NUCLEAR REGULATORY COMMISSION

Title: Advisory Committee on Reactor Safeguards
Thermal-Hydraulic Phenomena Subcommittee

Date: Friday, August 20, 2003

Sump Screen Design Elements

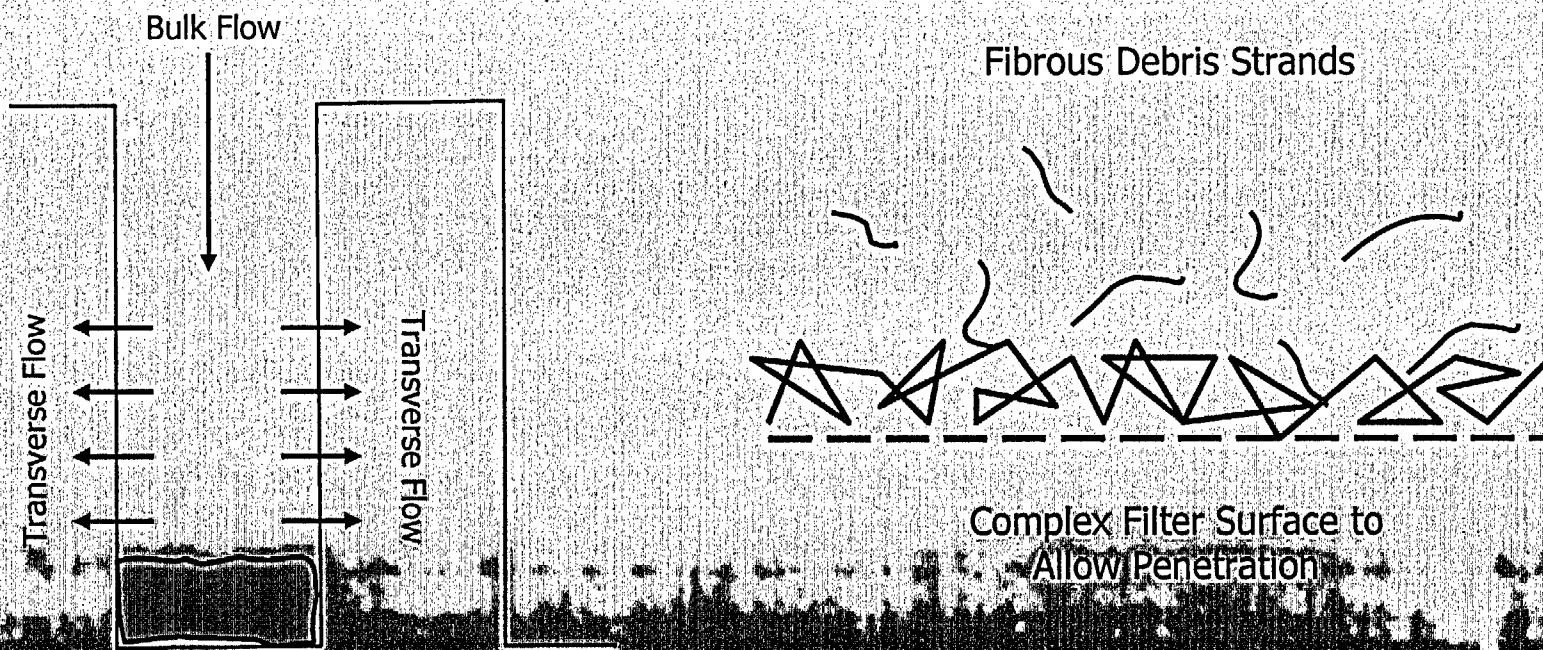
4 The third comment is the Reg. Guide
5 appears to favor a particular configuration of screen
6 because of the cartoons we have in the Reg. Guide. We
7 tried to clarify, to change the caption, saying that
8 those are conceptual features -- to indicate that they
9 are conceptual in nature.

Response - "Conceptual features" have been added to **Figures 1 and 2**.
